STAFF REPORT 11-16-2022 REGULAR MEETING

APPLICATION NUMBER: 22-8093

ADDRESS: 226 ARDEN PARK

SCOPE: ERECT 2ND STORY GARAGE ADDITION, REHABILITATE FRONT AND REAR PORCHES, REPLACE DRIVEWAY

View of the garage and garden wall, from alley. Staff photo, November 1, 2022.

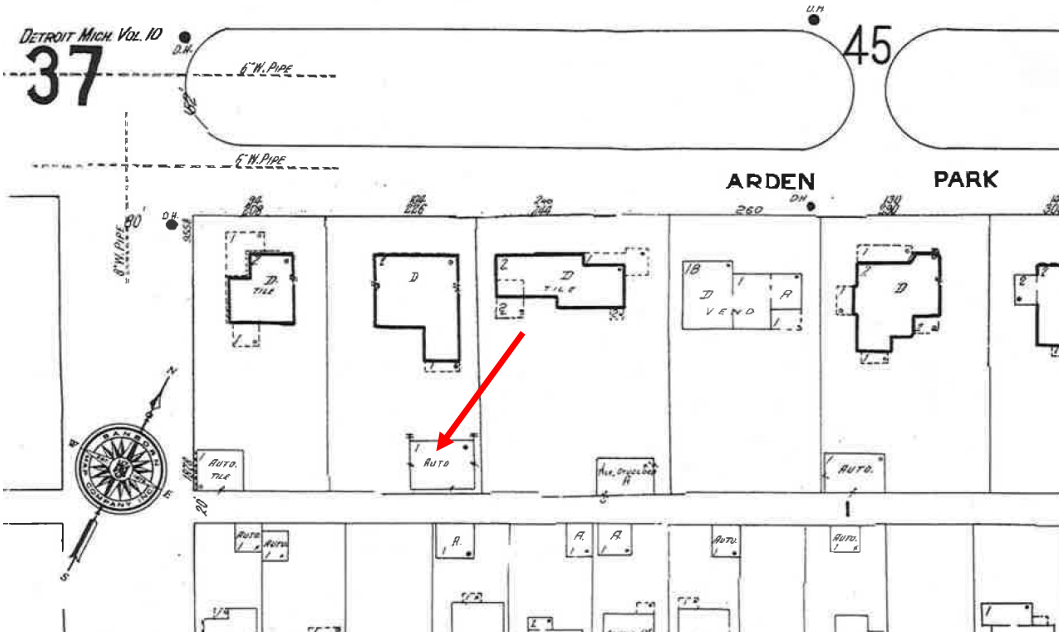
The existing garage, at the rear of the parcel, takes several design cues from the main house, including brick and stone ornamentation. It features original wood windows in apparently fair condition, with original garage door at alley. The more prominent street-facing elevation has lost more integrity, with modern garage doors and other incompatible infill elements installed decades ago. The former pitched roof of the garage is no longer extant, having deteriorated and been replaced at some point with a flat substitute. Overall, the garage is in poor condition.

The adjacent brick garden wall enclosing the rear property line, matching the brick used on the buildings, is in very poor condition with active loss of brick.
